COLORADO
Division of Reclamation,
Mining and Safety
Department of Natural Resources

February 13, 2023

Re: Lorencito Canyon Mine (Permit No. C-1996-084)
Review of Permit Renewal Application No. 5 (RN-5)
Second Adequacy Review

FIGURE 1. AREAS WHERE RILLS, GULLIES AND SPARSE VEGETATION HAS BEEN FOUND TO BE A PERSISTENT PROBLEM AT THE SITE ARE WITHIN THE DOTTED CIRCLE AREAS. BACKGROUND IMAGE IS THE 2020 ANNUAL REPORT MAP.

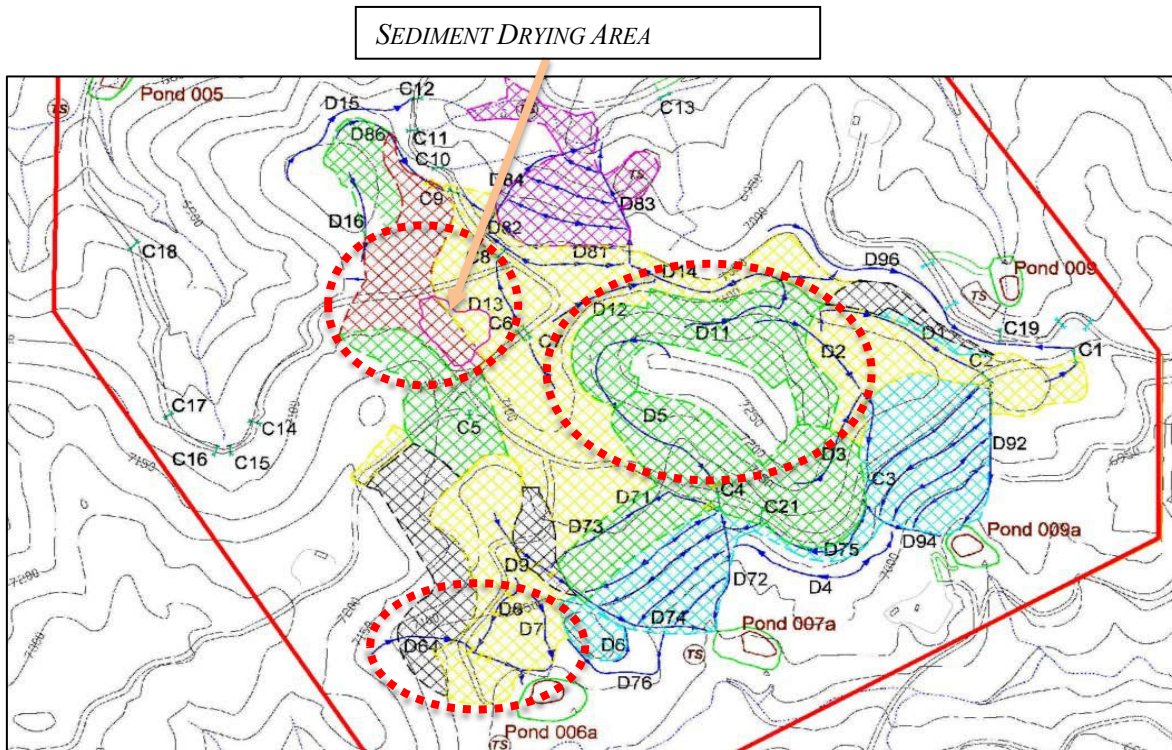
11. Significant rills, gullies, and areas with sparse vegetation have been noted in the reclaimed areas around the “Knob”, areas reported to have been reclaimed in 2006 and 2005 located above the area where pond and ditch cleanings are being stored, and areas reported to have been revegetated in 2007/2004 above Pond 006a. These areas are shown in the figures below. NECC has utilized several erosion control methods including the placement of straw waddles perpendicular to some of the eroded slopes, and the placement of brush within rills and gullies. The brush does seem to help prevent the rills from growing, and the brush seems to catch and hold soil and growth medium. Given the age of the reclamation of these areas in question, NECC will need to evaluate these areas to determine the best methods to fill, regraded, or otherwise stabilized these areas from erosion in accordance with Rule 4.14.6. Also, it is likely these areas will need to be reseeded in places given the sparse nature of the vegetation that has established. Please update the rill and gully plan to address how these areas will be stabilized in accordance with Rule 2.05.4(2)(c).

- DRMS — Page 2.04-59 corresponds with issue #10 from the preliminary adequacy review. Page 2.05-69 submitted with the adequacy response corresponds with this issue. The page 2.05-69 submitted with the adequacy response is the same as page 2.05-68 in the current PAP, but it is missing Table 2.05 4-4. If this is a mistake, please let the Division know and we will disregard the new 2.05-69 submitted with the adequacy response and refer to the current pages 2.05-68 and 2.05-69 within the PAP.

- DRMS — NECC states that NECC plans on addressing the rills and gullies by regrading or reseeding actions, and that this is planned to be addressed in 2023. NECC has a limited rill and gully plan included in the current page 2.05-69 of the PAP. In accordance with Rules 2.05.4(2)(c) and 4.14.6, please expand on this plan to include a proposal for addressing the

specific areas highlighted in Figure 1. Be sure to identify these areas in the PAP as needing to be treated during this permit term. The Division requires NECC to create and submit a formal plan for addressing these issues at this time. This plan needs to be created and reviewed prior to approval of the permit renewal RN-5.

- NECC — Page 2.04-59 has been revised to mention if more drastic erosion problems need to be addressed. For the areas mentioned in the adequacy review, NECC does plan on either addressing the rills and gullies by regrading and reseeding actions as noted in the plan. NECC is also thinking considering making revisions to the PAP to cut ditches in some areas that are steep and have tough time slowing water. NECC is planning on addressing these in 2023.
